Groundwater Application Review Summary Form

Application # G- 19475

PUBLIC INTEREST REVIEW FOR GROUNDWATER APPLICATIONS

A. GENERAL INFORMATION: Applicant's Name: Spurlin Farm, Inc. County: Linn

Well Statistics

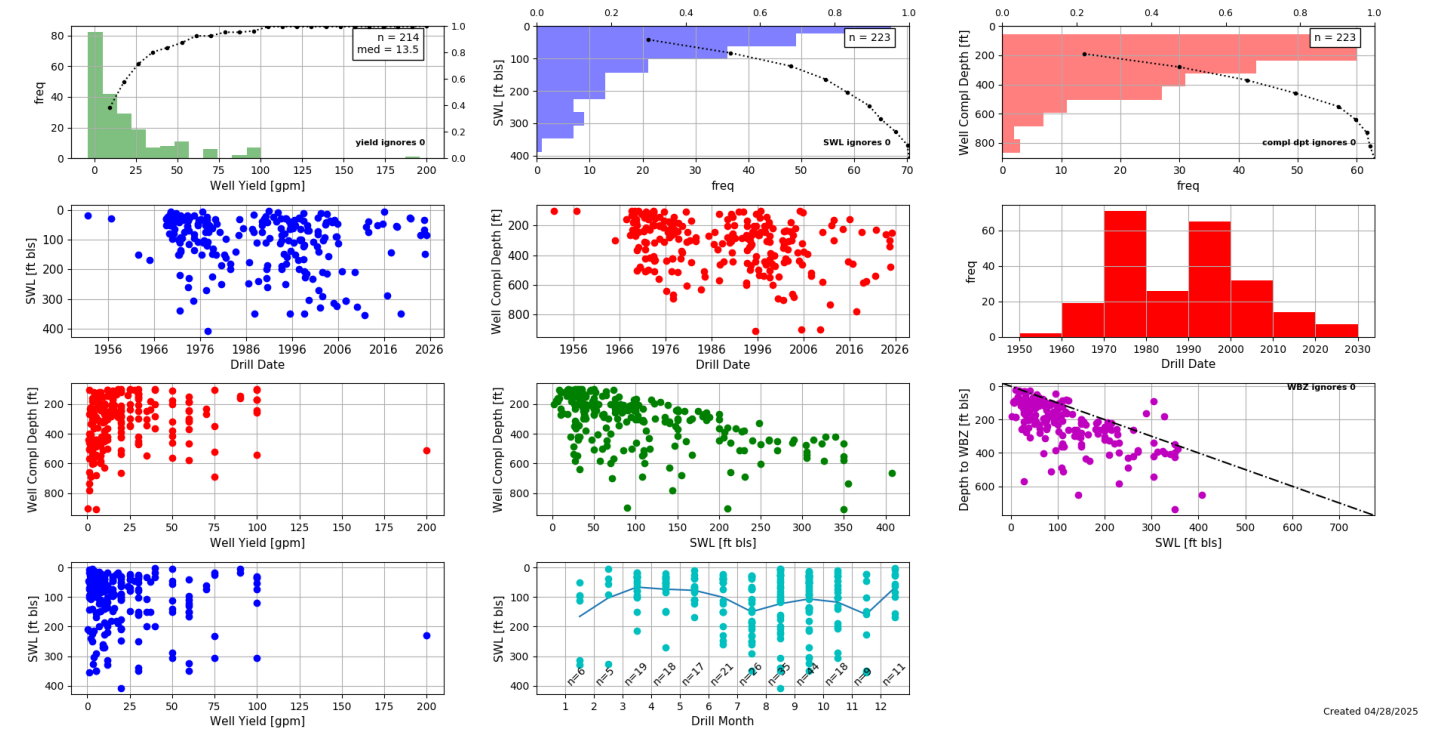
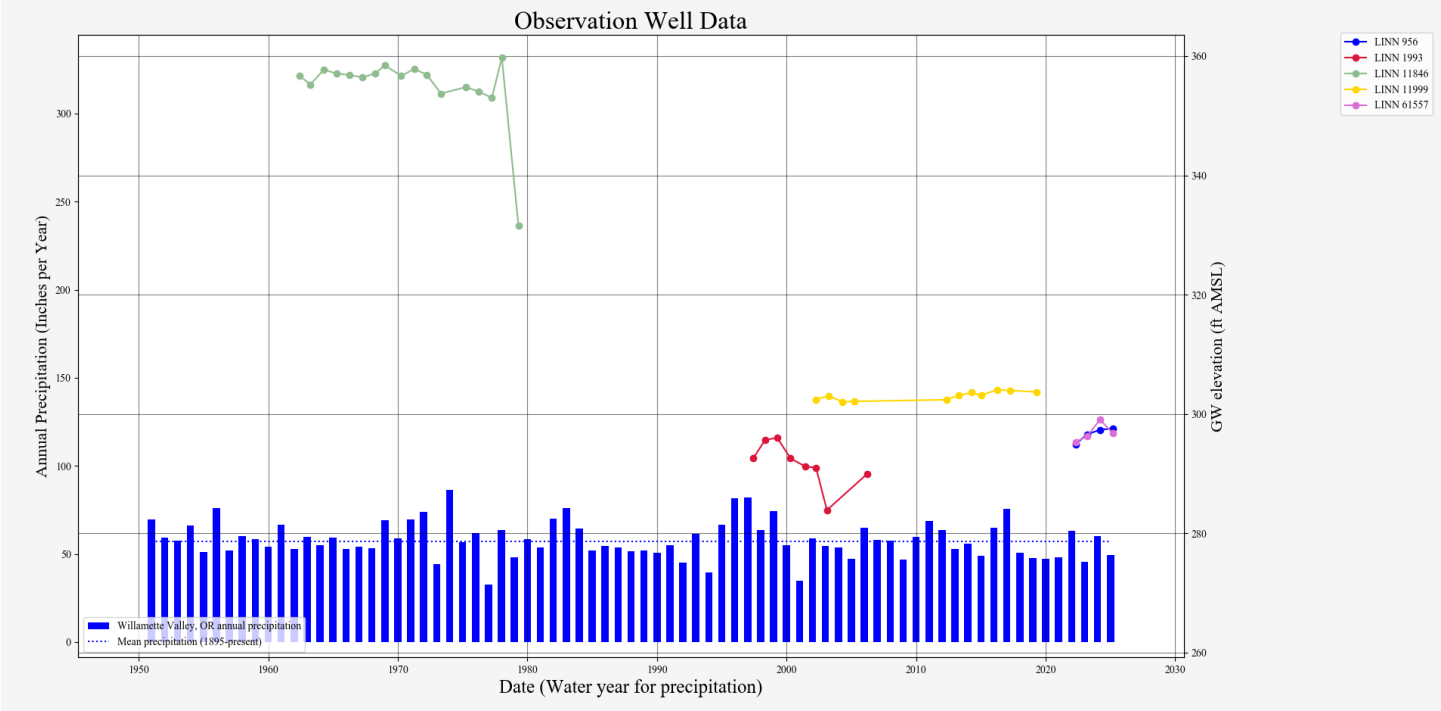
A review of statistics for nearby well records was completed and compared with the proposed rates of 1.16 cfs (520.6 gpm) for POA 1 and 0.95 cfs (426 gpm) for POAs 2 and 3 for this application (see Well Statistics). **The proposed rates are not likely within the capacity of the groundwater resource**; the median reported well yield for surrounding sections is 13.5 gpm and the maximum is 200 gpm. The proposed rate for POA 1 of application is 3857% of the median and 260% of the maximum; the proposed rate for POAs 2 and 3 is 3158% of the median and 213% of the maximum. The maximum yield of 200 gpm from LINN 11640 was obtained with an air test, which is not as accurate as a pumping test. In addition, the well record for LINN 11640 indicates it has an open interval from 49 to 510 ft bls.
Department SWL data for the bedrock aquifer is limited in this area to five wells within three miles and this limited data indicate water level trends are steady (see Water Level Measurements in Nearby Wells). LINN 11846 has not had any data reported in the last 46 years, LINN 1993 has not had data reported in 19 years, and LINN 11999 last reported six years ago. The two remaining wells (LINN 956, LINN 61557) have four consecutive years of data including the current year. There are 29 domestic wells and two groundwater POAs within a mile of the proposed POAs in this application. Those POAs are LINN

Based on this analysis of the available data and under the assumptions previously identified, groundwater for the proposed use is NOT likely not within the capacity of the resource; if a permit is issued for this application, the conditions in B1(d)(i) and B2(c) are recommended to protect senior users and the groundwater resource.

Water-Level Measurements in Nearby Wells

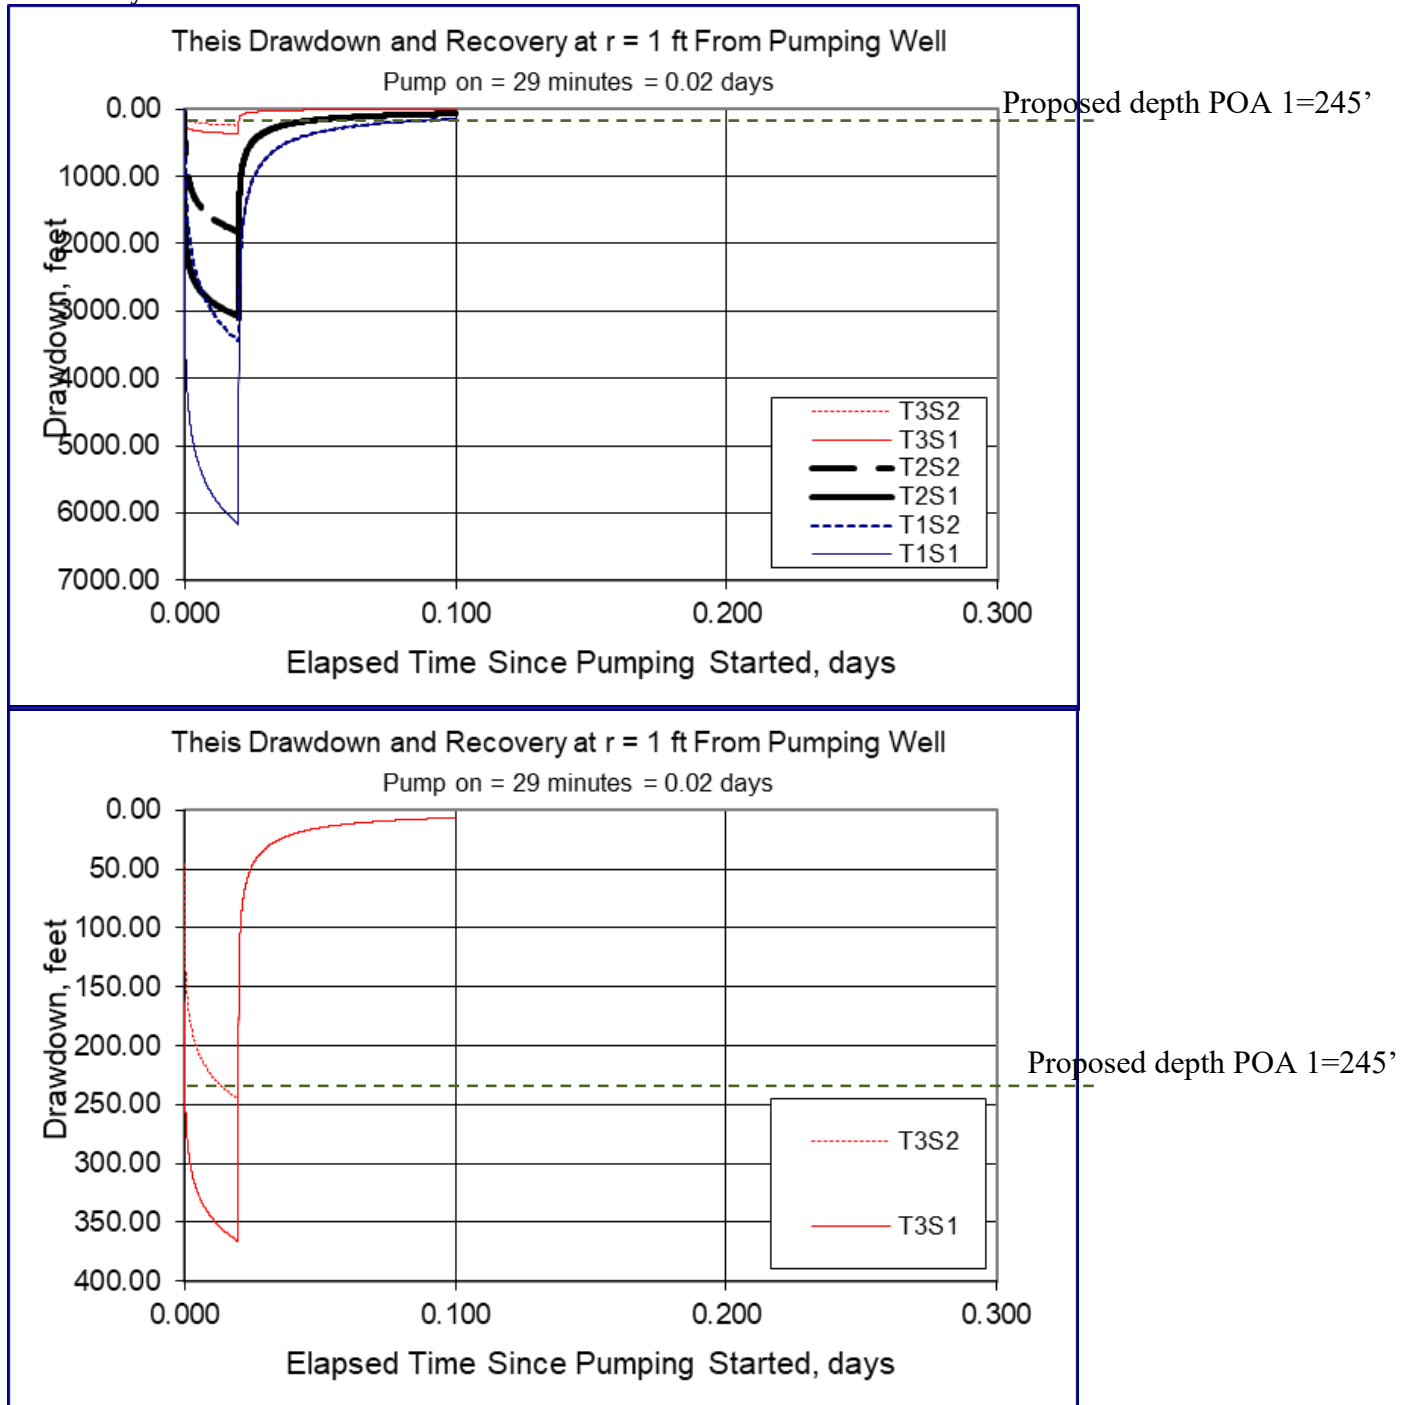
956 and LINN 61557 (wells with recent water level data above) and are on the same water right. Based on the limited water level data, it appears that the groundwater resource is not over-appropriated.

Theis Analysis-POA 1

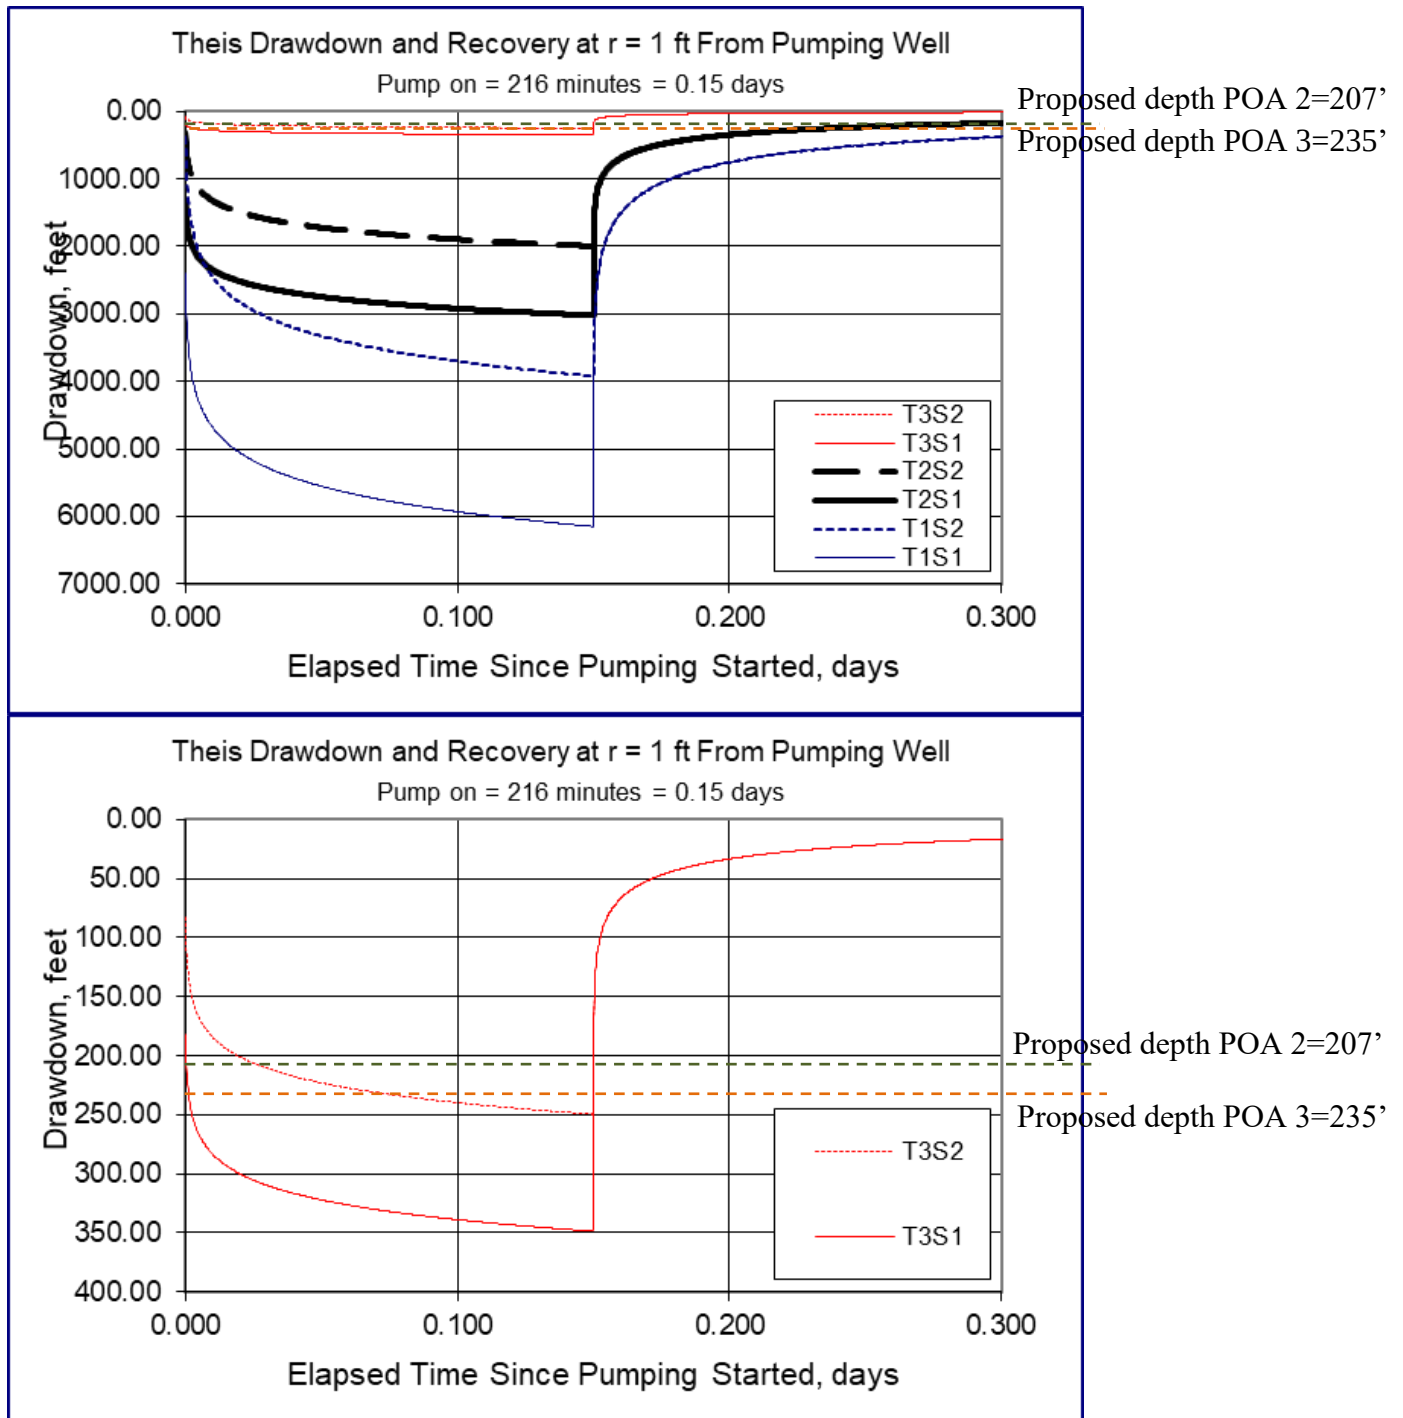
A Theis drawdown analysis on the total drawdown within the pumping well was completed for the proposed maximum rates and compared to the maximum depth of the proposed well. Results indicate that the proposed rates of 1.16 cfs for POA 1 and 0.95 cfs for POAs 2 and 3 are likely completely dewater the POAs in less than 30 minutes, 40 minutes, and 2 hours, respectively. Therefore, the proposed use is not in the capacity of the resource.
